# London Luton Airport Expansion

Volume 8 Additional Submissions (Examination)  
**8.118 Applicant's Response to Issue Specific Hearing**  
**4 Action 7 - Updates on Road Safety Audits (Tracked**  
**Change Version)**

Application Document Ref: TR020001/APP/8.118

Figure 2.1: Locations of Problems Identified within the Audit

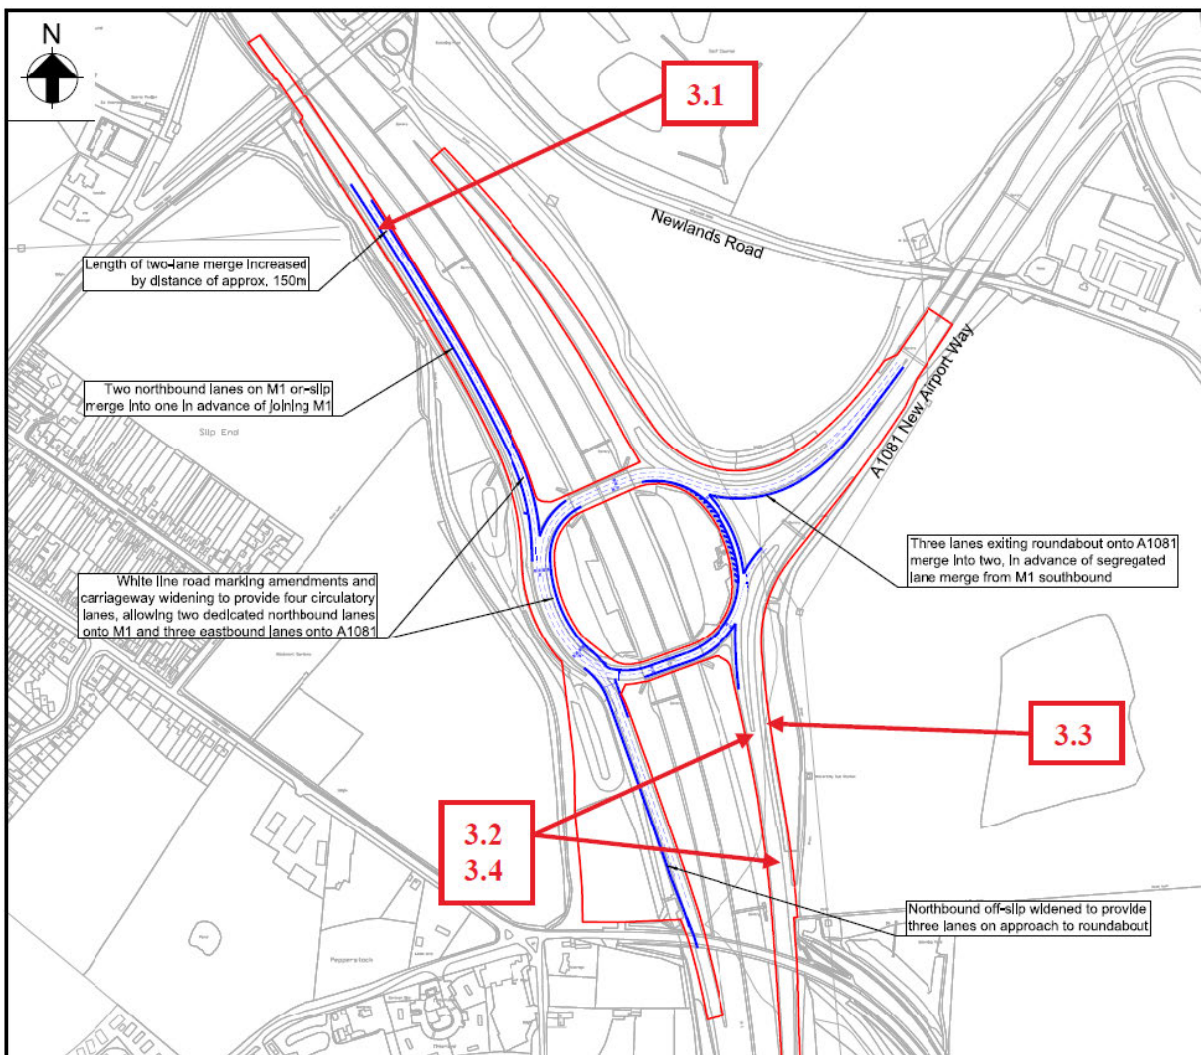
| Ref. | RSA Problem   | RSA Recommendation   | Design Organisation Response  | Overseeing Organisation Response  | Agreed RSA Action   |
|------|---|--|---|---|---|
| 3.1  | Drawing LLADCO-3C-ARP-SFA-HWM-DR-CE-0009 indicates that the length of the two-lane merge is to be extended by 150m. This may result in forward visibility of the merge point being compromised by an existing hidden dip in the northbound on-slip. This problem increases the risk of side swipe and loss of control type collisions.  | Ensure that sufficient forward visibility of the merge is maintained.        | Accepted. Forward visibility would be checked at the detailed design stage to ensure that appropriate visibility of the merge is maintained.  | <u>National Highways agree with the RSA. Traffic on the slip will be visible but the designer has agreed to checks.</u>   | <u>Forward visibility would be checked at the detailed design stage to ensure that appropriate visibility of the merge is maintained.</u>   |

| Ref. | RSA Problem  | RSA Recommendation  | Design Organisation Response   | Overseeing Organisation Response  | Agreed RSA Action  |
|------|--|---|--|---|--|
| 3.3  | <p>In Phase 2a and Phase 2b a two lane segregated left turn from the A1081 onto the M1 southbound slip road has been proposed. The existing southbound lane from the M1 J10 roundabout is proposed to join the segregated lanes with a short length of off-side merge. No details regarding infrastructure or stopping sight distances have been provided. Items such as VRS and signs between the segregated left turn lanes and off-side merge may obscure visibility for road users. This issue may increase the risk of side swipe, shunt, and loss of control type collisions. This</p> | <p>Provide sufficient intervisibility between the merge and segregated left turn lanes.</p> | <p>Accepted. See above response to Item 3.2 regarding the design or removal of the merge. If the exit off the circulatory is retained, there is scope to amend the alignment of the segregated left turn and separating island in order to accommodate potential VRS, signage and visibility requirements. This would be addressed at the detailed design stage.</p> | <p><u>National Highways agree with the RSA.</u></p> <p><u>It would be interested to explore the potential for closing the eastern circulatory or S/B merge exit as mentioned. That could remove a couple of issues, but signing for route finding would be key.</u></p>   | <p><u>Amend the alignment of the segregated left turn and separating island in order to accommodate potential VRS, signage and visibility requirements. This would be addressed at the detailed design stage.</u></p> <p><u>The opportunity to close the eastern circulatory or southbound merge will be considered at the detailed design stage.</u></p>  |

Figure 2.1: Locations of Problems Identified within the Audit

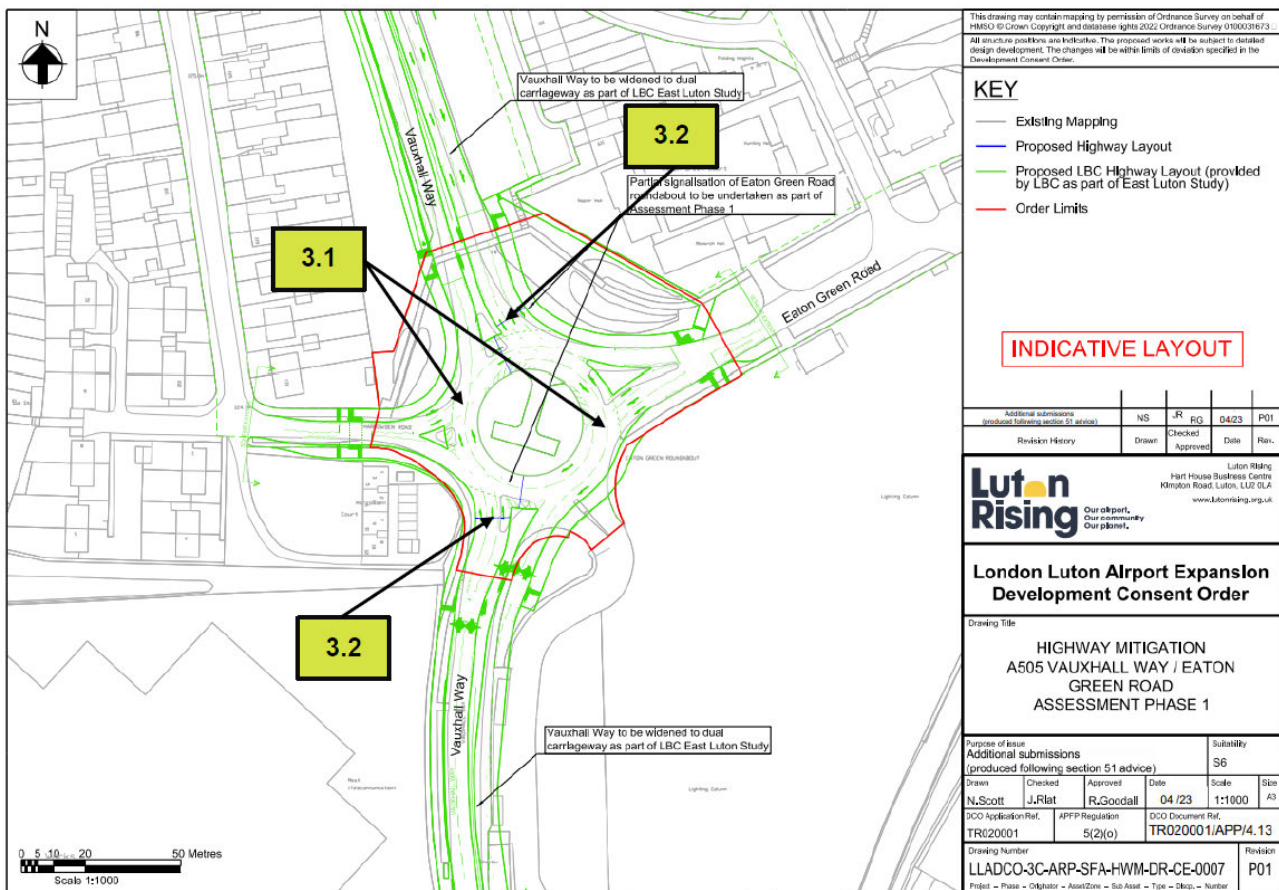
| Ref. | RSA Problem   | RSA Recommendation   | Design Organisation Response   | Overseeing Organisation Response                    | Agreed RSA Action   |
|------|---|--|--|---|---|
| 3.1  | The stacking distance between successive signal stop lines is quite short, which could lead to vehicle queues extending across the Harrowden Road and Eaton Green Road entries to the roundabout. As a result, collisions could occur as road users attempt to weave through queues or change lane suddenly.                                    | It should be ensured that the road layout and traffic signalling strategy is suitable to prevent vehicles queuing across entry arms to the roundabout. | Accepted. The operation of the signals would be optimised to ensure the efficient operation of the junction and would include consideration of queue lengths within the circulatory carriageway of the roundabout. | <a href="#"><u>Design Response is accepted.</u></a> | <a href="#"><u>RSA recommendation to be adopted as part of the detailed design.</u></a> |
| 3.2  | The widening to three lanes on the approaches to the junction could increase the likelihood of the primary signals being masked by high sided vehicles. If a red signal is not clearly visibly to road users, there could be an increased risk of overshoot collisions or accidents involving sudden and late braking, such as rear-end shunts. | High-mounted duplicate primary signals should be provided on the Vauxhall Way approaches to the junction.  | Accepted. The provision of high-mounted signals would be considered at the detailed design stage.  | <a href="#"><u>Design Response is accepted.</u></a> | <a href="#"><u>RSA recommendation to be adopted as part of the detailed design.</u></a> |

Figure 2.1: Locations of Problems Identified within the Audit

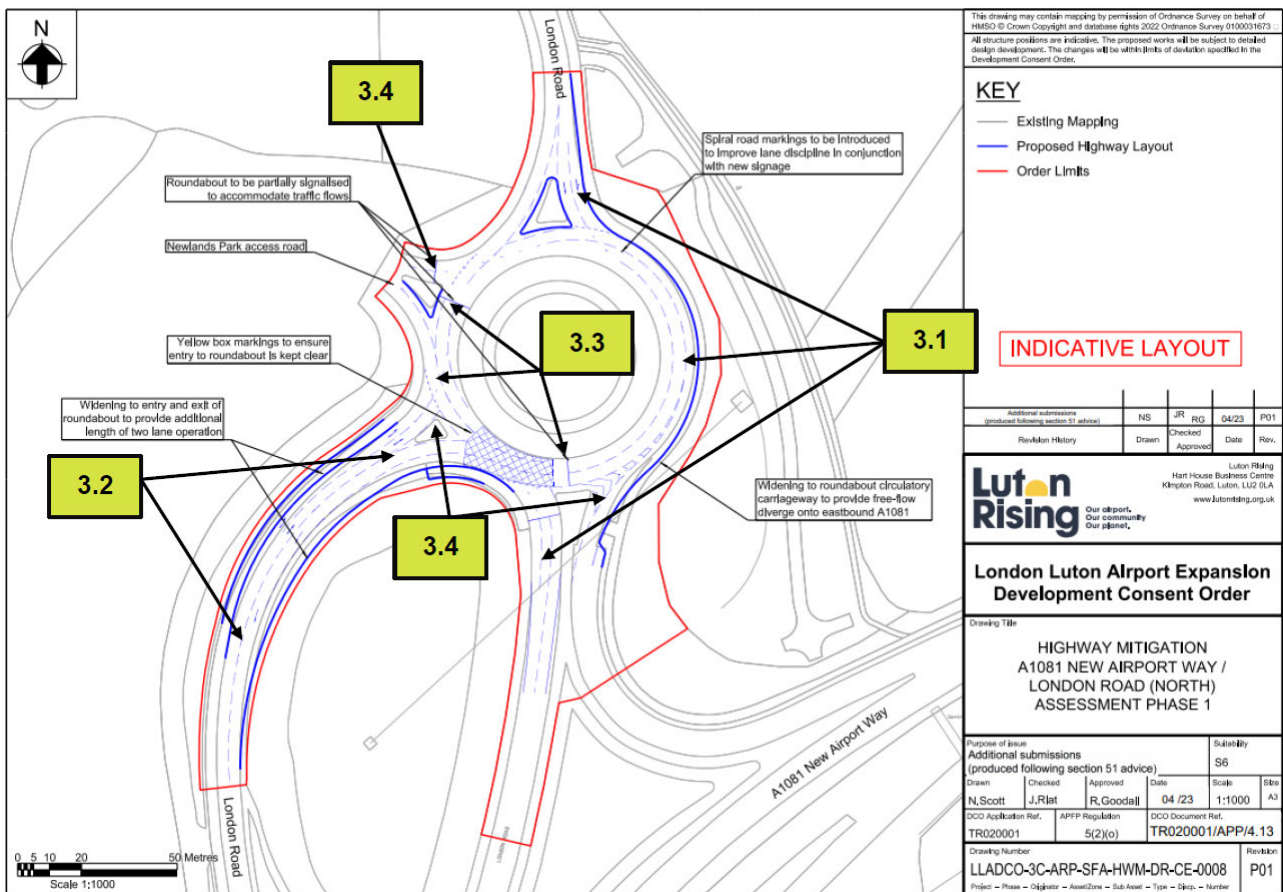
| Ref. | RSA Problem   | RSA Recommendation  | Design Organisation Response   | Overseeing Organisation Response                    | Agreed RSA Action   |
|------|---|---|--|---|---|
| 3.1  | Road users may not be able to anticipate which lanes to use to reach their intended destination. For example, on the A1081 approach, road users may use the middle lane to reach London Road (north) rather than the designated offside lane. On the London Road southbound approach, road users may use the offside lane to reach the A1081 (which they can currently), instead of using the nearside lane only. If road users find that they are in the incorrect lanes, side swipe and lane change collisions could occur. | Lane destination signs and road markings should be provided at strategic locations to inform road users of the correct lanes to use.      | Accepted. Lane markings and signage would be provided to clarify which destinations are reached from each approach lane. This would be addressed at the detailed design stage. | <a href="#"><u>Design Response is accepted.</u></a> | <a href="#"><u>RSA recommendation to be adopted as part of the detailed design.</u></a> |

| Ref. | RSA Problem   | RSA Recommendation   | Design Organisation Response   | Overseeing Organisation Response   | Agreed RSA Action   |
|------|---|--|--|--|---|
| 3.3  | <p>The stacking distance between successive signal stop lines is quite short, which could lead to vehicle queues extending across the London Road southern entry to the roundabout. As a result, collisions could occur as road users attempt to weave through queues or change lane suddenly.</p>  | <p>It should be ensured that the road layout and traffic signalling strategy is suitable to prevent vehicles queuing across entry arms to the roundabout.</p>          | <p>Accepted. The operation of the signals would be optimised to ensure the efficient operation of the junction and would include consideration of queue lengths within the circulatory carriageway of the roundabout.</p>  | <p><u>Design Response is accepted.</u></p>   | <p><u>RSA recommendation to be adopted as part of the detailed design.</u></p>          |
| 3.4  | <p>The widening of the roundabout could make crossing movements more hazardous for pedestrians and cyclists, especially at times of high vehicle flows (peak times) or when speeds could be higher at off-peak times. This could be a particular issue on the London Road southern arm and on the A1081 exit arm. On the Newlands Park access entry to the roundabout, the position of the signal stop line could make it difficult to provide a crossing point. Vulnerable road users could be at increased risk of being struck by vehicles under such circumstances.</p> | <p>It should be ensured that the pedestrian and cycle crossing points will be safe to use (for example, controlled crossings may be beneficial at some locations).</p> | <p>Noted. The proposed realignment on the A1081 exit arm increases the crossing distance by approximately 1.0m and could be reduced at the detailed design stage to minimise any additional crossing distance.</p> <p>The pedestrian demand on the London Road (south) exit arm is likely to be very low, and the proposed signalisation of the A1081 arm should create gaps in the traffic for pedestrians to cross. In addition, the widening to the London Road exit is c1.5m and would only add c.1 second to the crossing time for pedestrians.</p> | <p><u>Design Response is noted. Recommend that non-motorised user demand is reviewed as part of the detailed design.</u></p> | <p><u>RSA recommendation is noted and overseeing organisation comment accepted.</u></p> |

Figure 2.1: Locations of Problems Identified within the Audit

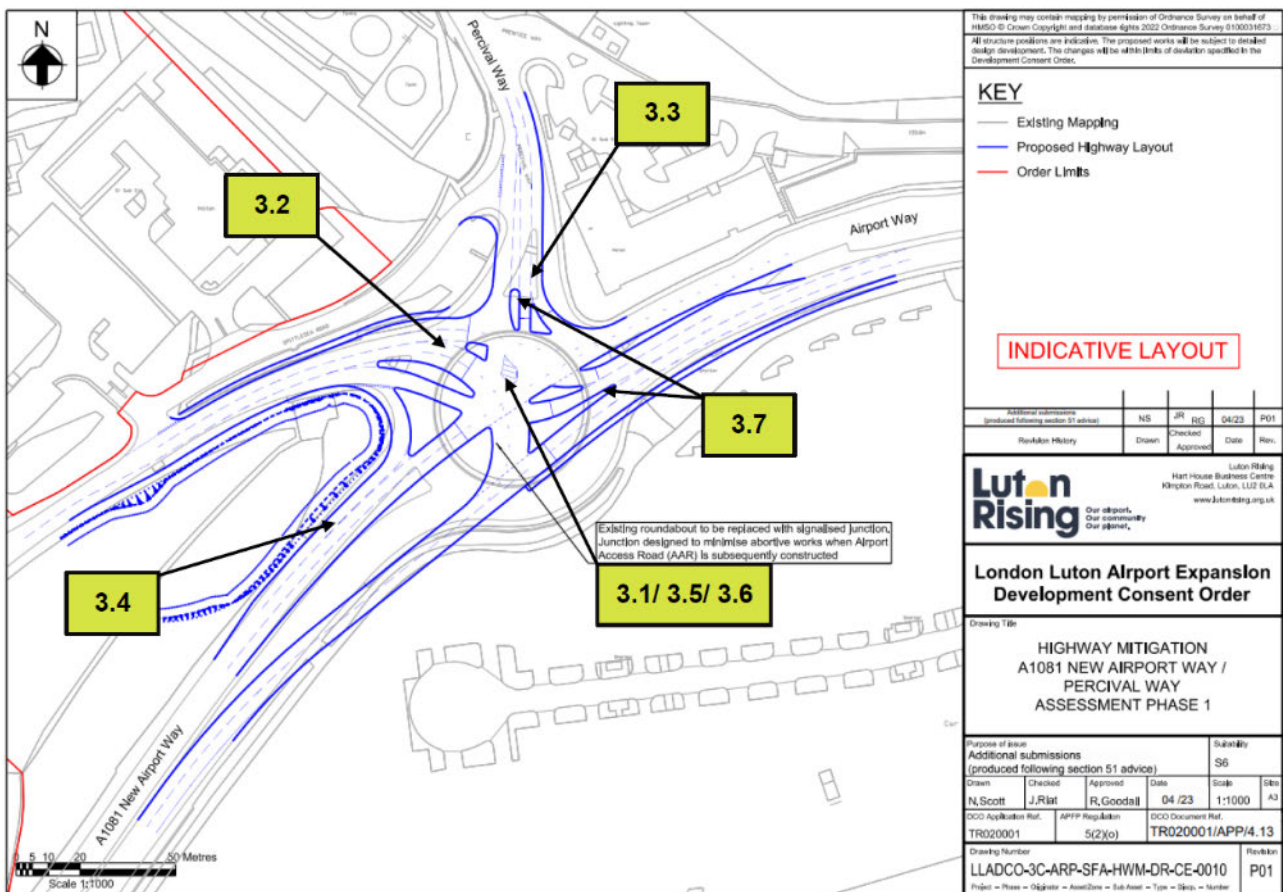
| Ref. | RSA Problem  | RSA Recommendation  | Design Organisation Response  | Overseeing Organisation Response   | Agreed RSA Action  |
|------|--|---|---|--|--|
| 3.3  | The vertical alignment for Percival Way on the approach to the junction is on a steep downhill section. With the introduction of the signal control there could be more sudden braking movements such as when the lights change from green to red. This combined with being on a downhill section could increase the risk of loss of control and subsequent shunt and junction overshoot collisions. | A level dwell area of suitable length should be created for this arm of the junction.   | Accepted. See response to 3.1.  | <u>Design Response is accepted.</u>  | <u>RSA recommendation to be adopted as part of the detailed design.</u>          |
| 3.5  | With numerous lanes and splitter islands, road users turning at the signalised junction might have difficulty manoeuvring into the correct lane for their required destination. These potentially late lane swapping manoeuvres could increase the risk of side swipe collisions with other users. Furthermore, they might get confused and turn into the incorrect                                  | At detailed design stage appropriate signing, lining and bollards should be installed at the junction to guide users to the correct lanes for their desired destination. Signal phasing should be reviewed ensuring minimal conflicts between opposing traffic                  | Accepted. Appropriate signage, road markings and bollards would be provided at the detailed design stage to reinforce appropriate manoeuvres throughout the junction.   | <u>Design Response is accepted.</u>  | <u>RSA recommendation to be adopted as part of the detailed design.</u>          |

| Ref. | RSA Problem   | RSA Recommendation  | Design Organisation Response   | Overseeing Organisation Response   | Agreed RSA Action  |
|------|---|---|--|--|--|
| 3.7  | It is not known at this stage if there are going to be any controlled crossing facilities at the proposed signalised junction. It is noted that for Airport Way and Percival Way there are existing shared footway/ cycleways and uncontrolled crossing facilities which link to a nearby hotel and car park area. With the new multilane signalised arrangements with greater crossing distances this could increase the risk of collisions with pedestrians and cyclists. | Pedestrian and cyclist movement should be reviewed around the junction and appropriate controlled crossing facilities should be installed where required such as Toucan crossings. These should also be compliant with the latest cycling guidance, such as LTN 1/20. | Accepted. There is flexibility within the junction design to accommodate crossing facilities on existing desire lines and this would be considered at the detailed design stage. | <u>Design Response is accepted.</u>  | <u>RSA recommendation to be adopted as part of the detailed design.</u>                                    |

Figure 3.1: Swept Paths - A1081 New Airport Way / Airport Way

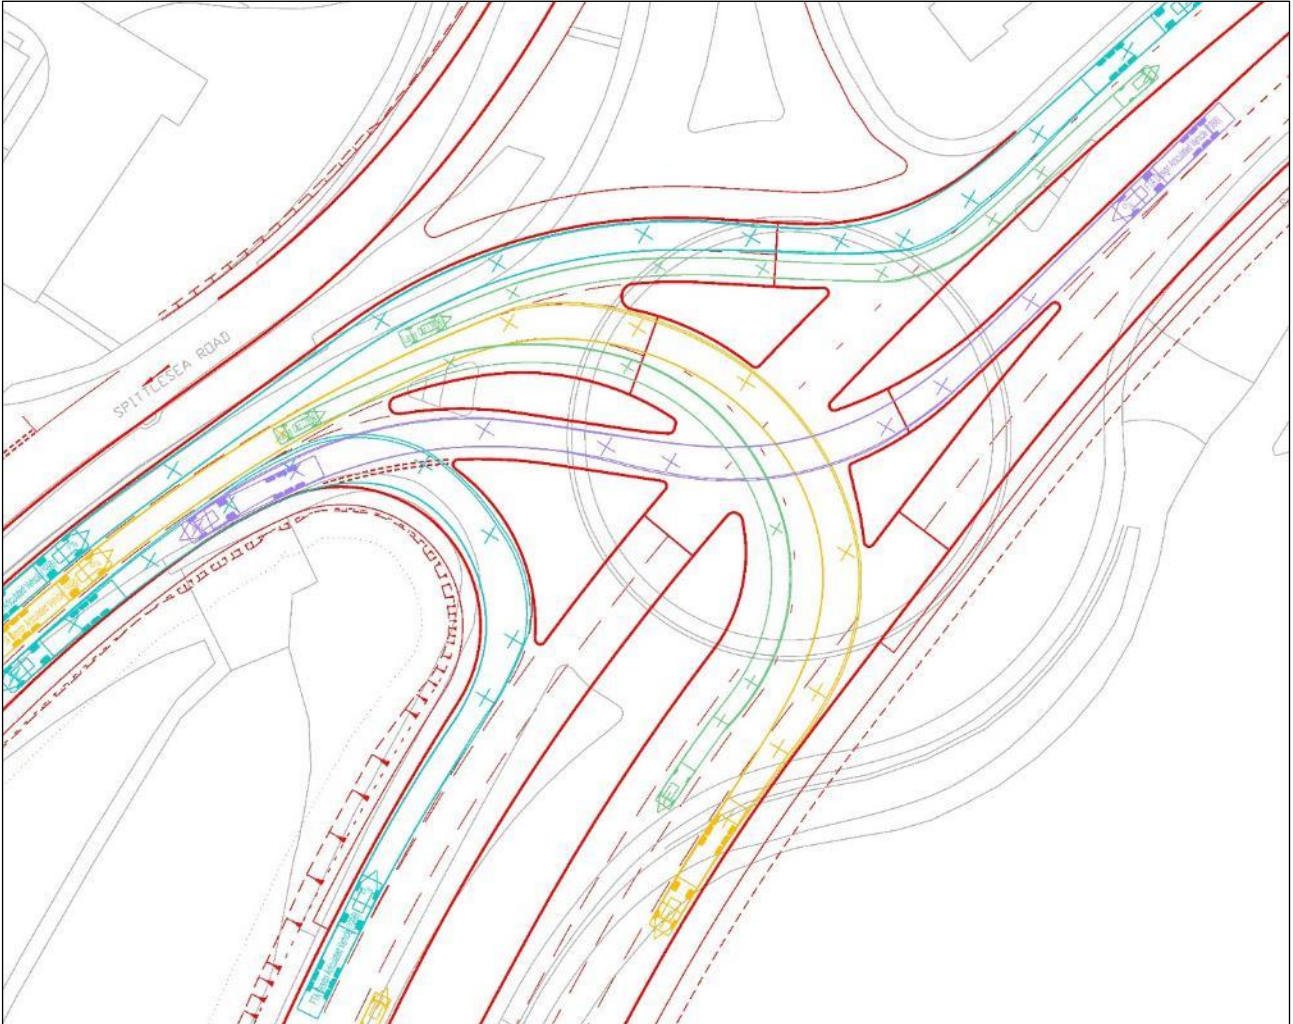
- 3.2.1 Figure 3.1 The image above shows the swept path analysis for 16.5m articulated HGVs and large cars at the signalised junction between A1081 New Airport Way, Airport Way and Percival Way.

**Figure 3.1: Potential Pedestrian Crossing Improvements**

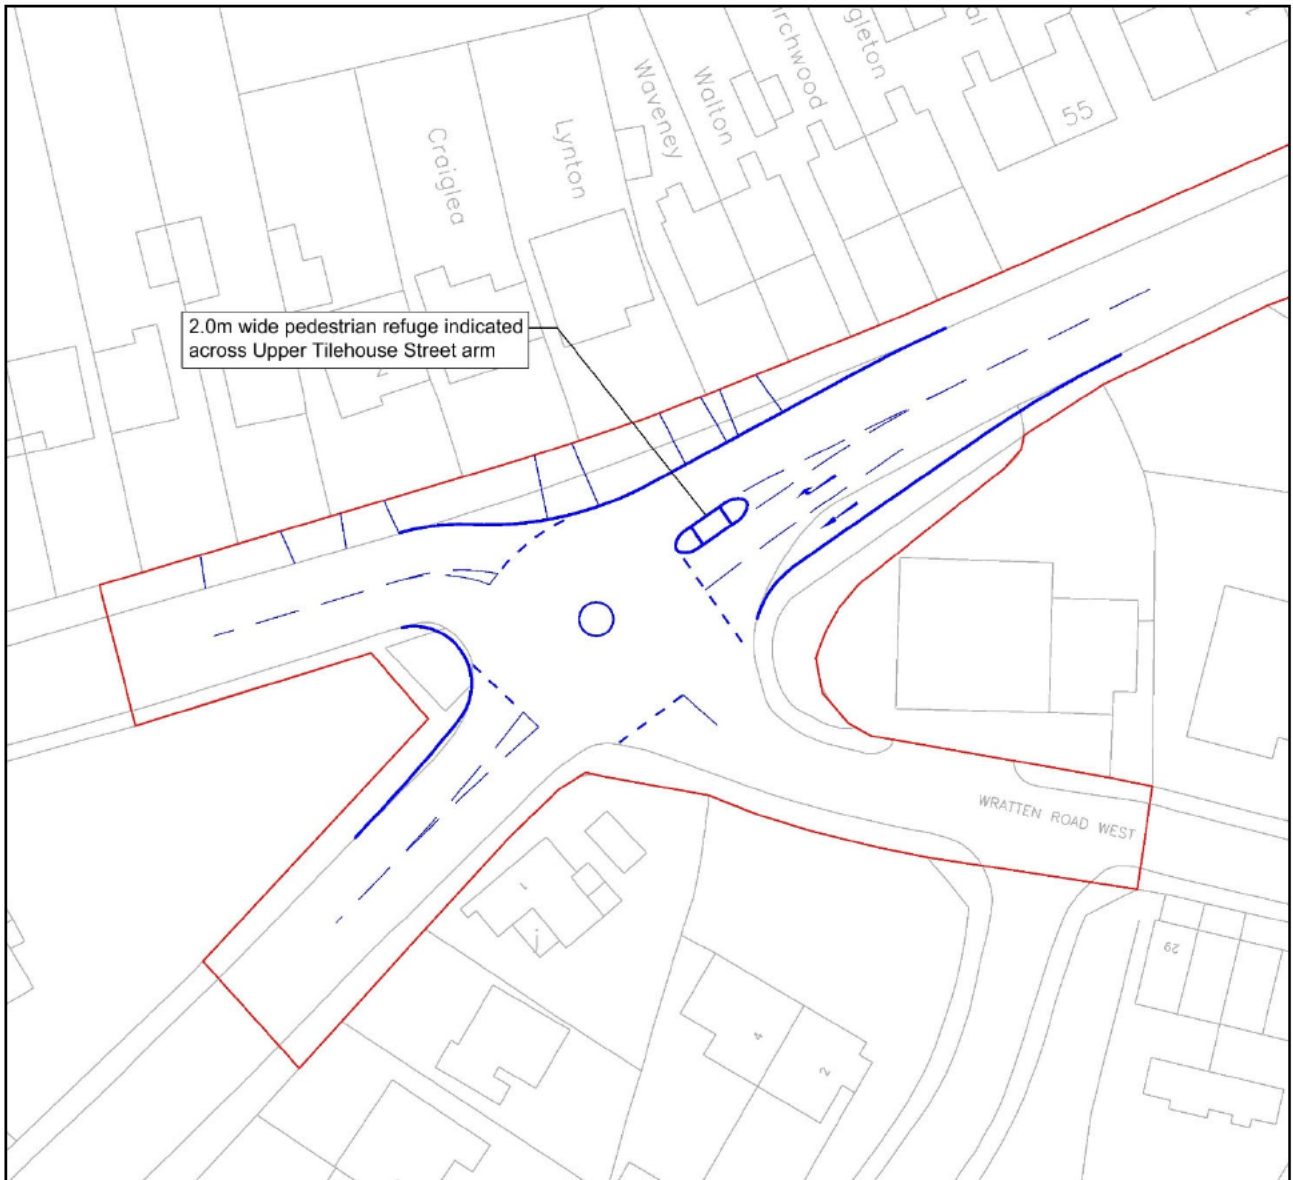
| Ref. | RSA Problem  | RSA Recommendation  | Design Organisation Response   | Overseeing Organisation Response  | Agreed RSA Action |
|------|--|---|--|---|-------------------|
| 3.2  | The widening to two lanes could make crossing movements more hazardous for pedestrians, especially at peak-times when traffic flows are likely to be high. This could increase the risk of pedestrians being struck by vehicles.   | An uncontrolled pedestrian crossing point should be provided, with a wider physical central island specified. | <u>Accepted. An uncontrolled crossing on Upper Tilehouse Street has been incorporated into the proposed layout as shown on Figure 3.1.</u>                   | <u>Disagree: At detailed design stage it is too late to address this issue. Pedestrian crossing facilities must be addressed at this stage in line with HCC policy.</u>   |                   |

**3.2.1** **Figure 3.1, below, shows an indicative arrangement to provide a pedestrian crossing on the eastern arm of the mini-roundabout.**

**3.2.2** **Figure 3.1 shows an indicative revised junction arrangement which incorporates a pedestrian refuge across Upper Tilehouse Street. Existing residential dropped kerb accesses are also highlighted along the northern side of Upper Tilehouse Street and Pirton Road, in the vicinity of the junction.**
